INDIANA DEPARTMENT OF TRANSPORTATION

APPROVED MINUTES

January 18, 2024, Standards Committee Meeting

RE: Minutes from the January 18, 2024, Standards Committee Meeting

E 801-TPAR-03 PEDESTRIAN DETOUR CROSSWALK CLOSURE (proposed new)

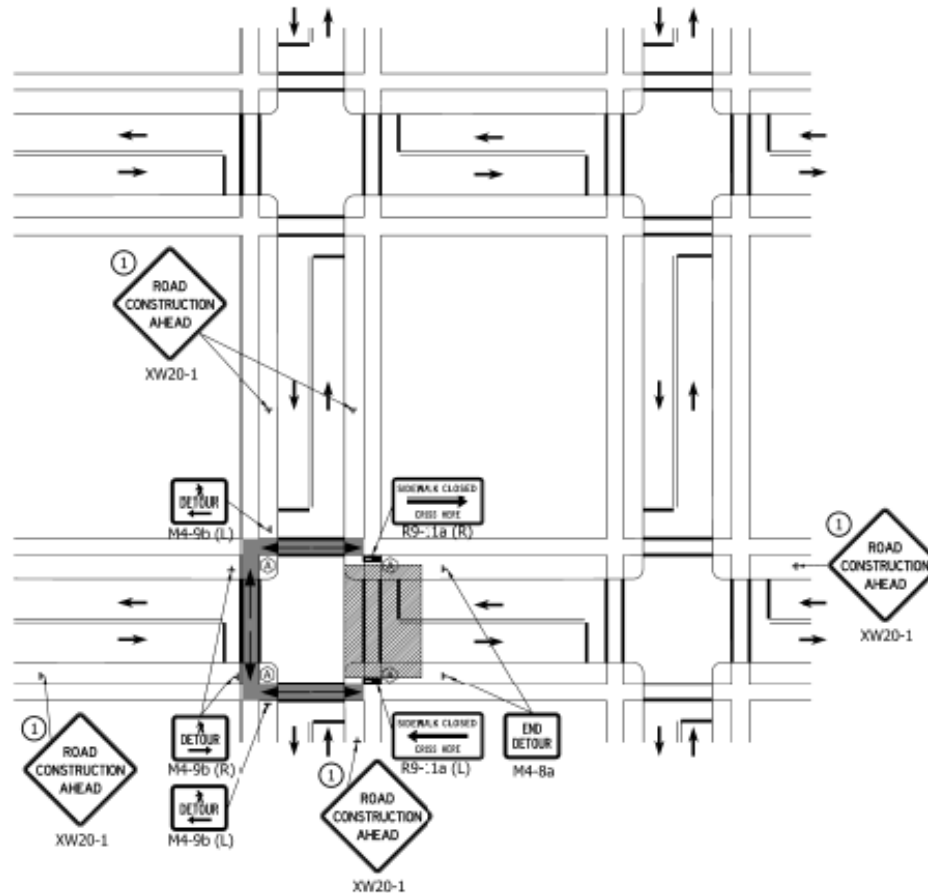
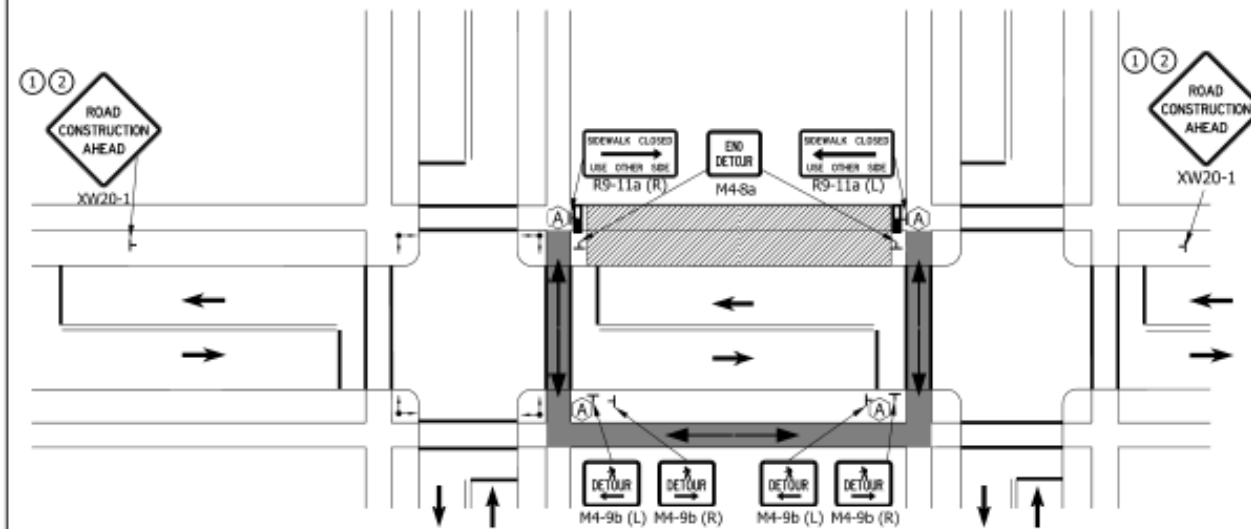
Mr. Koch stated, concerning the 801-TPAR drawings-02, -04, -05, -06, -07, -08, -10: everyone has RCA's. In order to minimize costs, burdens, and liability if the note is overlooked, and the associated costs to change out signage as the work progresses and to maintain a stock of the signs; please consider striking note #2. Also, for drawings 801-TPAR-03, -05, -07, understand we are attempting to capture both approaching sidewalks yet we are adding a considerable amount of sign clutter. Are two RCA's needed as a single is utilized elsewhere? And for 801-TPAR-10, the corner diversion requires 'sidewalk construction ahead' yet includes note #2. Similar to elsewhere, should RCA's be required 1st, ideally only RCA's for simplification. Mr. Boruff responded that we could make it an option, which would eliminate the liability and added costs concerns. The Contractor can use RCA's if they have them in stock or would otherwise prefer the alternate, more precise message. Mr. Koch said that sounds reasonable. The drawings have been revised as shown, following discussions by Mr. Duncan from FHWA, Mr. Koch, Ms. Smutzer, Mr. Davis, and Mr. Boruff.

E 619-PRWS-03 COATING REQUIREMENTS FOR EXISTING STRUCTURAL STEEL ENCASED IN CONCRETE (proposed draft, revised)

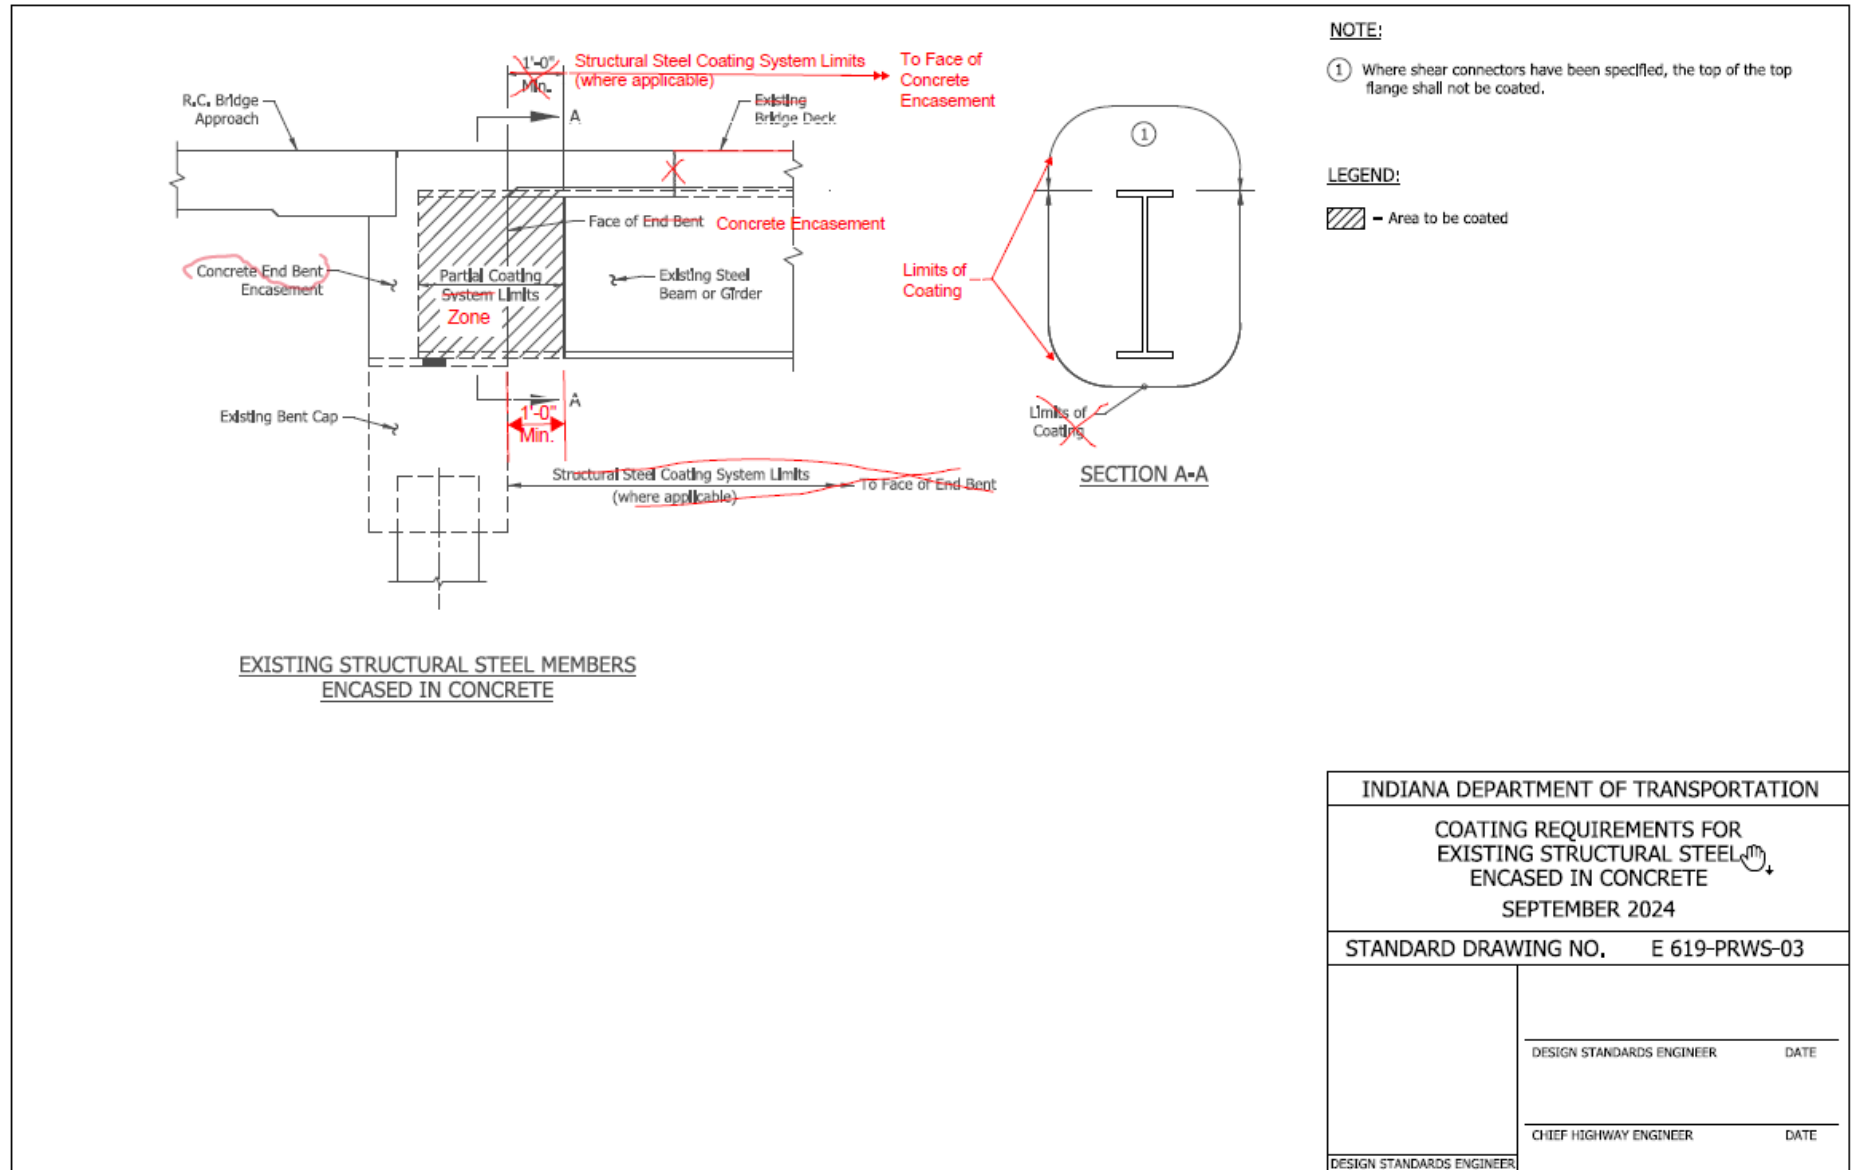
Ms. Mouser showed revised drawings and explained the revisions (E 619-PRWS-03).

Mr. White proposed the acceptance of the drawings revised as shown.
